VOLVO PENTA

Service Bulletin

Campaign: Demon™ Carburetor, Throttle Plate Screws 3.0GLP-J, 4.3GL-J, 4.3GL-JF

IMPORTANT! this revised bulletin contains a change in the procedure for checking the carburetors. See page 4.

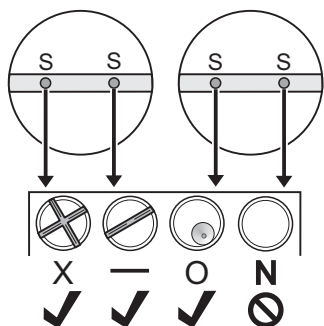
IMPORTANT! this section contains a change in the procedure for checking the carburetors.

The end of each screw (S) should be staked (X, —) or dimpled (O). The staking or dimpling prevents the screw from backing out. Screws that are not (N) staked or dimpled may back out, and must be repaired (details below).

All four screws must be staked (X,—) or dimpled (O). If all four are staked or dimpled the carburetor passes inspection and should be returned to service. See “If the Carburetor Passes the Inspection” below.

If the stake or dimple mark is missing (N) on the end of **any** of the four screws, the carburetor fails the inspection and must be removed and repaired, see “If the Carburetor Fails the Inspection” below.

If the end of any screw is marked, but it looks like the staking tool did not completely hit the screw, the carburetor fails the inspection and must be removed and repaired, see “If the Carburetor Fails the Inspection” below.
